## **IRENE-STILLWOOD SUBDIVISION**

APPLICATION NUMBER 20 DATE October 16, 2003  
APPLICANT Irene-Stillwood Subdivision  
REQUEST Subdivision

# IRENE-STILLWOOD SUBDIVISION

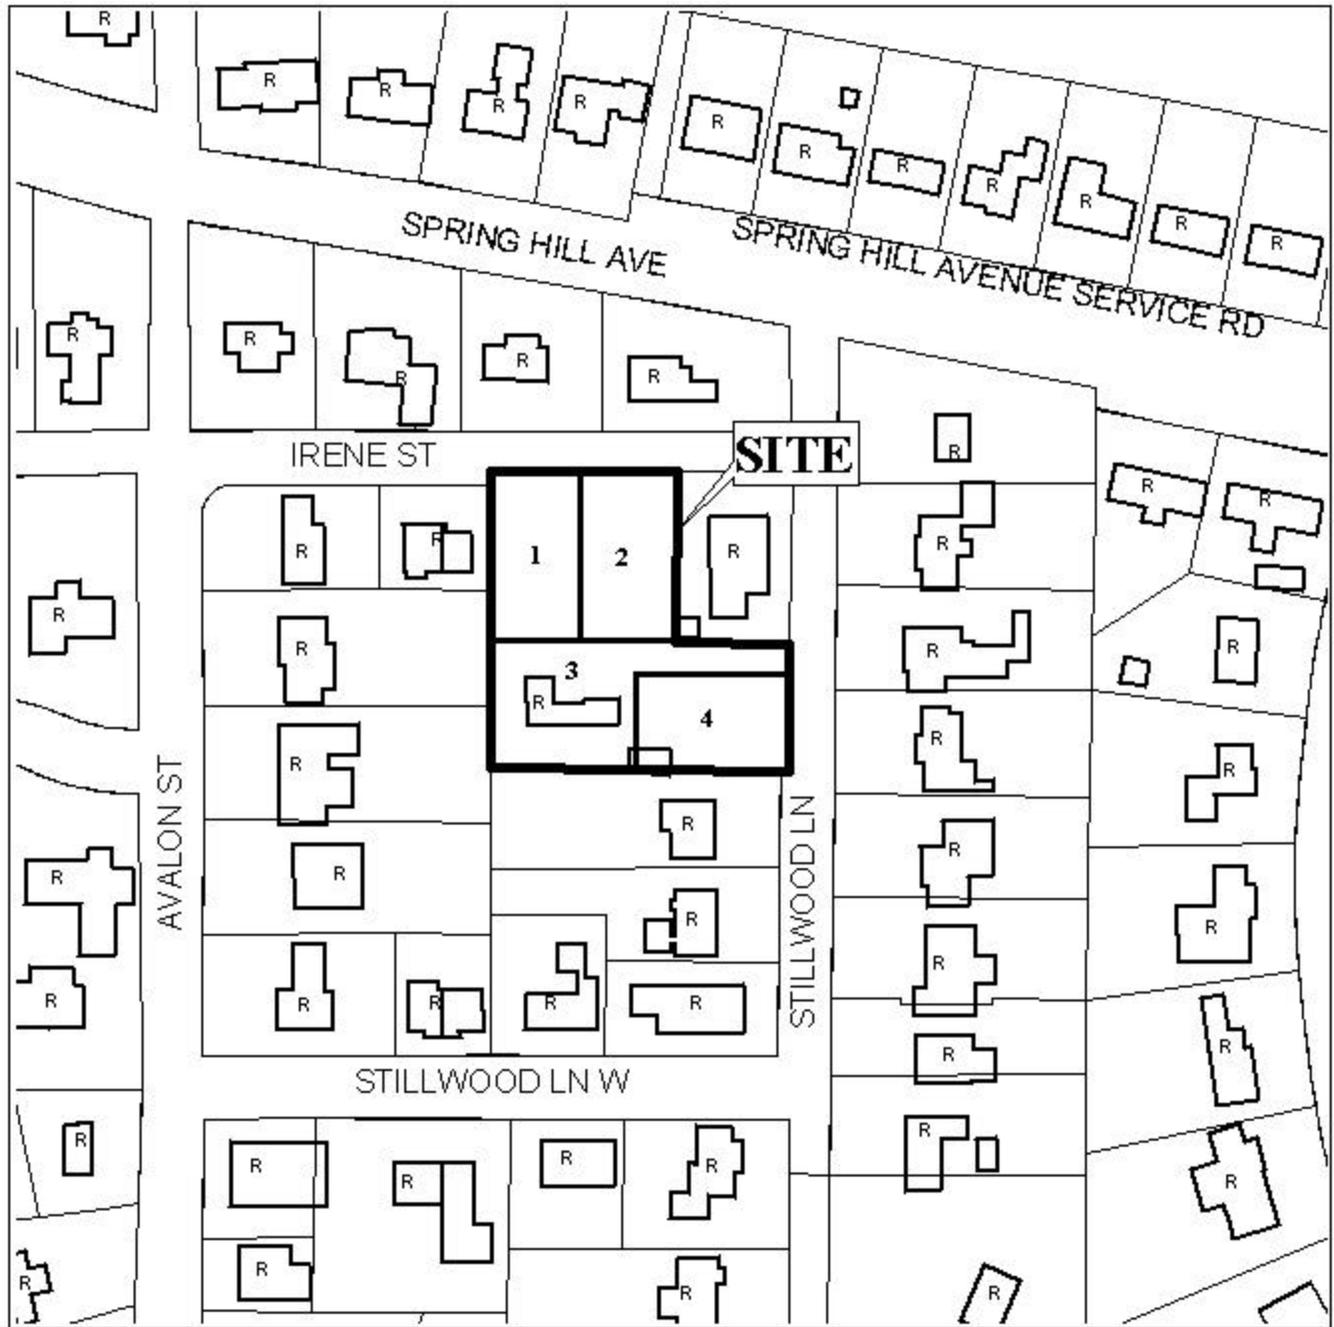
The site fronts Irene Street and Stillwood Lane, both minor streets having substandard rights-of-ways of 30' and 33' respectively; therefore, the dedication of adequate right-of-way to provide 25' from the centerline of Irene Street and Stillwood Lane should be required.

Although this subdivision as proposed meets the minimum density requirements of the Subdivision Regulations, the awkward lot configuration of Lot 3 would result in a poor development pattern of one home looking into the rear of another home, and is a good example of why the Subdivision Regulations have minimum width requirements, and a width to depth ratio. Furthermore, Lot 3 exceeds the maximum width to depth ratio as recommended by the Subdivision Regulations; therefore, a waiver of Section V.D.3. would be required.

Based on the preceding this application is recommended for denial for the following reasons: 1) the proposed subdivision would be out of character with the surrounding development and would result in one home looking into the rear of another home; and 2) Lot 3 does not comply with Section V.D.3 (width to depth) of the Subdivision Regulations.
